**Re: GE-Pittsfield/Housatonic River Site
Rest of River (GECD850)
Dispute Resolution on Certain Conditions in EPA's Conditional Approval Letter for GE's
Work Plan for Evaluation of Additional Remedial Alternatives**

**GENERAL ELECTRIC'S STATEMENT OF POSITION ON
DISPUTED CONDITIONS 20 AND 22 OF EPA'S
CONDITIONAL APPROVAL OF GE'S WORK PLAN FOR
EVALUATION OF ADDITIONAL REMEDIAL ALTERNATIVES**

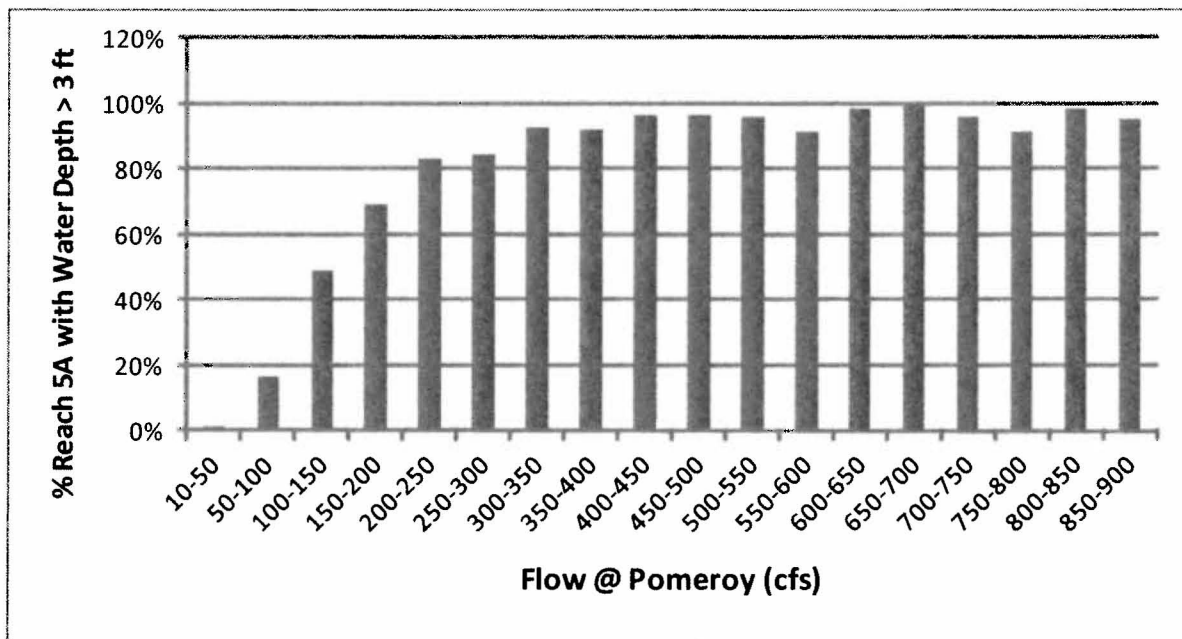
GE's conclusion that river conditions in Reaches 5A and 5B would limit the ability to work in the river and thus warrant a further reduction in the production rate is supported by review of the number of days when water depth would prevent safe operation of equipment within the river channel in Reach 5A. For purposes of this analysis, it is assumed that conventional equipment could not operate safely in water depths greater than 3 feet, so if a substantial portion of the river (e.g., more than 75%) had water depths over 3 feet, work within the river channel would not be able to be performed. GE has estimated that this would occur, on average, on approximately 36 days over the assumed annual 198-day construction season.¹¹ This estimate was based on use of the hydrodynamic model developed by EPA. The graph below shows the percentage of area in Reach 5A having model-predicted water depths greater than 3 feet during the assumed construction season, corresponding to various ranges of flow (at Pomeroy Avenue Bridge near the upstream end of Reach 5A).¹²

¹² This plot was developed based on the model predictions of water depth over the full range of flow events simulated in EPA's 26-year validation period. The percentages shown correspond to the area of grid cells within Reach 5A that are predicted to have a water depth greater than 3 feet at the given flow range.

The above figure shows that more than 75% of Reach 5A will have water depths greater than 3 feet during the assumed construction season¹³ when flow in the river at Pomeroy Avenue exceeds 200 cubic feet per second (cfs). Review of the flows in EPA's model during that season over the 26-year model validation period indicates that the average number of days per construction season in which flow exceeds 200 cfs is approximately 36 (which represents 18% of the assumed 198-day construction season). This illustrative analysis supports GE's additional adjustment for flow-related downtime in Reach 5A (beyond the general adjustment for downtime).
